Addendum No. 5

Lake Charles Public Works New Facility Phase 2
4200 Broad Street
Lake Charles, LA

Project No.: DR002

City of Lake Charles
326 Pujoe Street
Lake Charles, LA

POWER AND SPECIAL SYSTEMS PLAN - VEHICLE MAINTENANCE

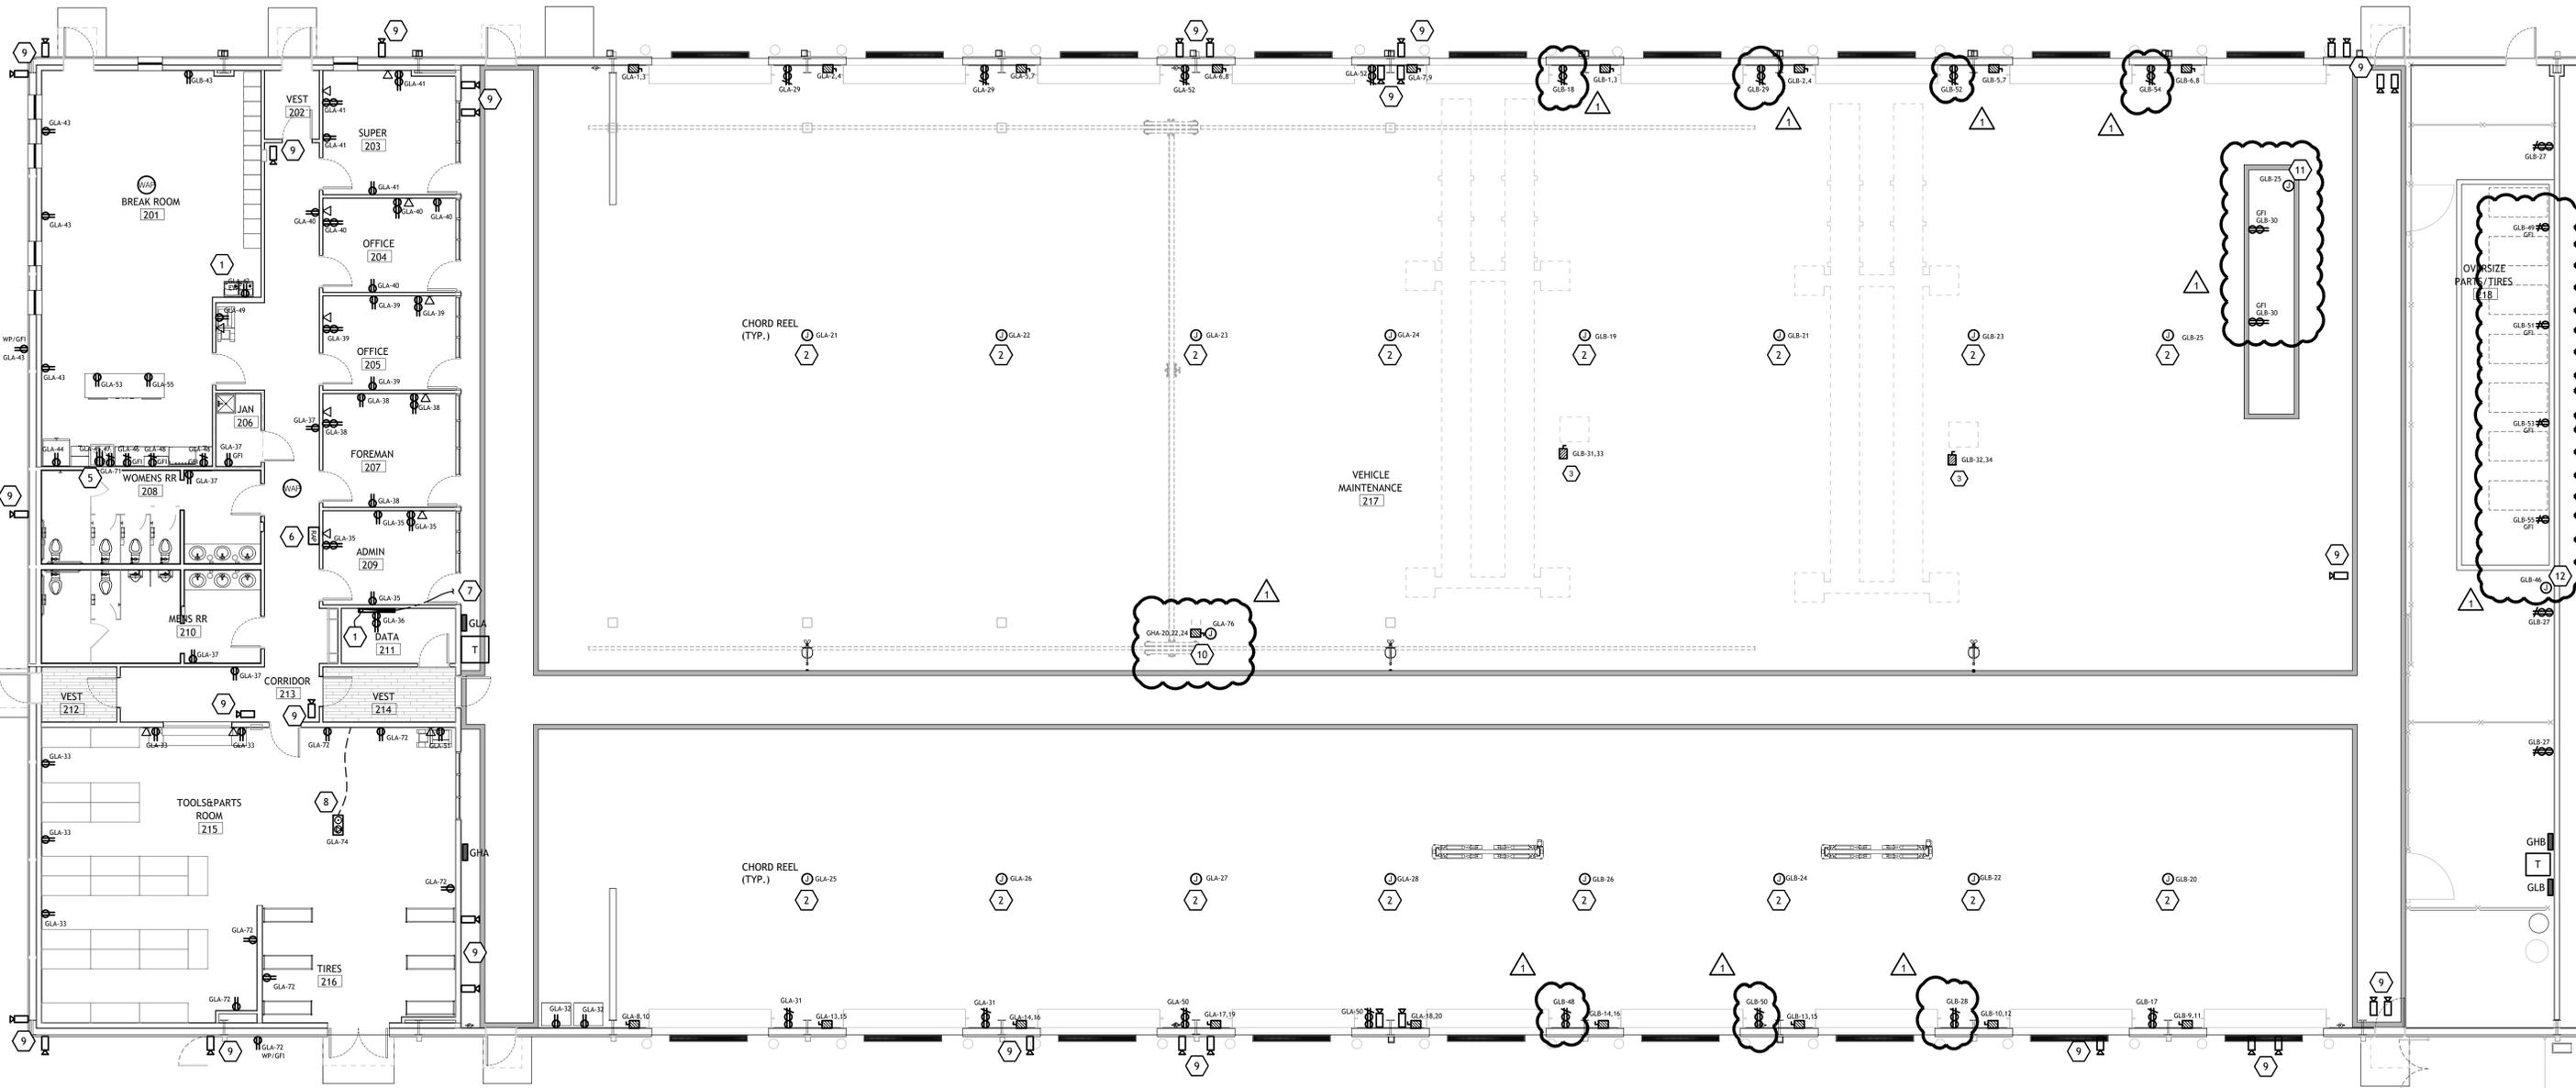
18. Disconnect switch for 10-ton crane shall be 600V, 3p60A, HD, NEMA 1, FDS. Fuse disconnect per manufacturer recommendation.
19. Fixture type 'P' does not require DMX control. Standard 0-10V (DIM 1%) dimming is acceptable.

1 POWER & SPECIAL SYSTEMS PLAN - FUEL STATION
SCALE: 1/16" = 1'-0"

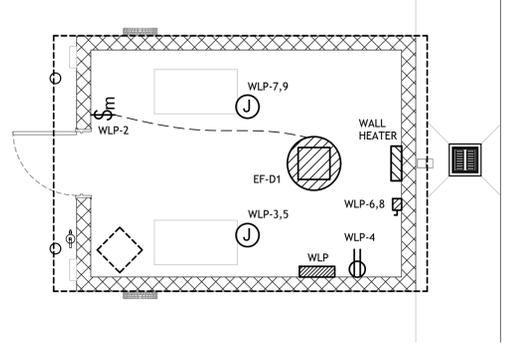
1. A1.1-1: Existing power poles (PP) noted to remove will not be installed in Phase 1 and will not be removed in this project.
2. A1.3-1: Water tank to be dark green and ANSI/FDA approved resin material.
3. A1.12-1: Diesel fuel tank to be 12,000-gallon size in lieu of 20,000 gallon as noted.
4. A1.12-1: All fuel tanks (diesel, gasoline, and dyed diesel) to be installed a minimum 25 ft away from property line.
5. A1.12-1: All fuel tanks to be UL 2085 rated.
6. A1.12-1: Provide safety emergency shut-off valve to stop the transfer of fuel to dispensers in accordance with IFC 2303.2.

7. A1.12-1: Fuel dispensers to be Diesel & Off-Road Diesel Hi-Flow Commercial Dispensers, Gasboy Commercial DEF Dispenser (warm weather), and Unleaded Gasoline Standard-Flow Commercial Dispensers.

9. A1.12-1: Contractor shall furnish and install a complete Above Ground Storage Tank (AST) fuel storage, monitoring, and dispensing system for this project. Equipment listed herein constitutes one of the approved products. Any other Substitutions require approval per Article 3 of instructions to bidders. Complete system shall comply with NFPA 30/NFPA 30A, International Fire Code (IFC), NEC Article 514, EPA SPCC (40 CFR 112) and all applicable state and local regulations

10. Above Ground Storage Tanks to be (Fireguard UL-2085) as follows: Diesel Tank: Fireguard UL-2085, double-wall steel, interstitial monitoring, overflow prevention, audible/visual high-level alarm; Unleaded Tank: Fireguard UL-2085, double-wall steel, interstitial monitoring, overflow prevention; Off-Road Diesel Tank: Fireguard UL-2085, double-wall steel, interstitial monitoring; DEF Tank Blue1 Southern Easy Tank with accessories, DEF-compatible materials, integrated containment. Provide tank monitoring system (Automatic Tank Gauge: Franklin Fueling Systems EVO 600 (inventory-only configuration) with Franklin inventory-only probes, Franklin ULS (Universal Leak Sensors) for tank and containment monitoring. Provide Franklin Fueling System Submersible Turbine Pumps (STPs) at 2 HP & ¾ HP, Mechanical line leak detectors installed per NFPA 30A and Franklin STP control boxes integrated with OPW PV200 system. Provide Fuel Control System. FCS to be OPW Petro Vend PV200 (Two (2) units), with capabilities of Driver PIN, Vehicle ID, transaction reporting, and pump authorization control. Piping System to be Franklin Fueling Systems UPP Double-Wall Piping between tanks and dispensers with continuous secondary containment with Franklin UPP single-wall dispenser sumps at each fuel dispenser and one at the fuel tank area. Electrical to be Classified wiring per NEC Article 514 with emergency stop within 100 feet. Provide Testing & Commissioning of complete system including Interstitial verification, pump testing, EVO setup, PV200 programming, and Owner training required. Provide two (2) OPW Petro Vend PV200 units shall be provided and installed as follows PV200 Unit #1 controls all fuel dispensers (diesel, unleaded, off-road diesel, and DEF) including pump authorization for associated Franklin STPs. Contractor Responsibilities shall include all Electrical, Communication, and Mounting and shall supply and install all electrical wiring, conduit, communication cabling, control wiring, and associated infrastructure required for full operation of the fuel systems. This includes, but is not limited to, power circuits, control circuits, data/communication cabling, interconnections between the EVO 600, OPW PV200 units, , STP control panels, dispensers, sensors, and all related components. Contractor shall also furnish and install all mounting hardware, brackets, supports, anchors, and structural attachments required for proper installation of fuel equipment, control panels, and monitoring devices. Provide and install minimum (2) 1" conduits per fuel dispensers to home run back to Room 215 with exact location to be by Architect. All electrical work shall comply with NEC requirements and applicable local codes. Coordination with other trades shall be the responsibility of the Contractor to ensure a complete and fully operational system. Provide all electrical wiring, conduit, communication cabling, control wiring, mounting hardware, and system integration required for fuel systems. Provide system startup, programming, testing, and Owner training. Provide stainless steel fueling islands manufactured by OPW as shown on the project plans. Furnish and install OPW stainless steel fueling islands at islands indicated on the dwgs. Manufacturer noted herein to be considered as approved equals.

12. A1.12-1: Fuel system installer to provide permit drawings as required per State and local requirements.
13. A2.12-1, Type C: Window type C to be "451T" in lieu of as noted.
